Addendum 106: Regulation No. 107

Revision 3 – Amendment 2

04 series of amendments to the Regulation - Date of entry into force: 28 October 2011

Uniform provisions concerning the approval of category M₂ or M₃ vehicles with regard to their general construction

Model A

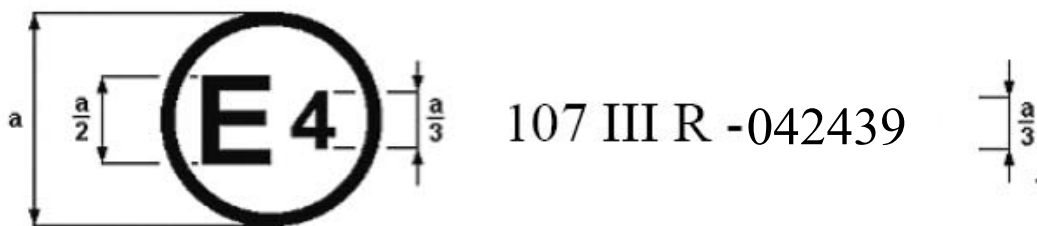
Annex 2, amend to read:

The above approval mark ... under approval number 042439. The approval number ... as amended by the 04 series of amendments.

Model B

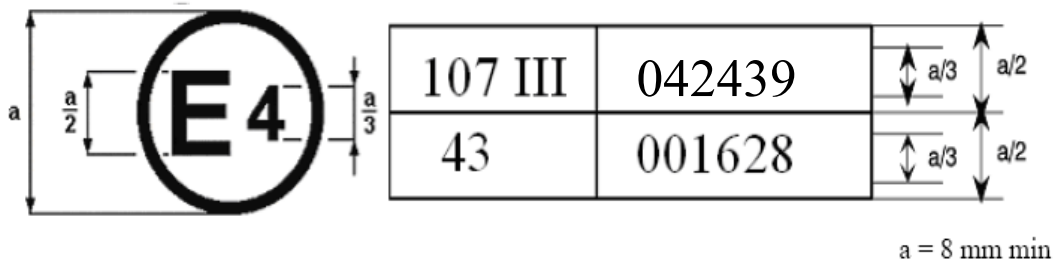
The above approval mark ... Regulation No. 107 included the 04 series of amendments and Regulation No. 43 was in its original form.

Model C

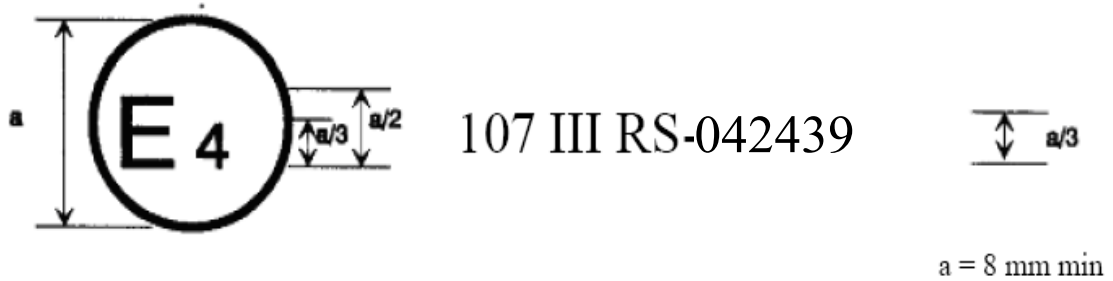
The above ... pursuant to Regulation No. 107 under approval number 042439. The approval number indicates ... as amended by the 04 series of amendments."
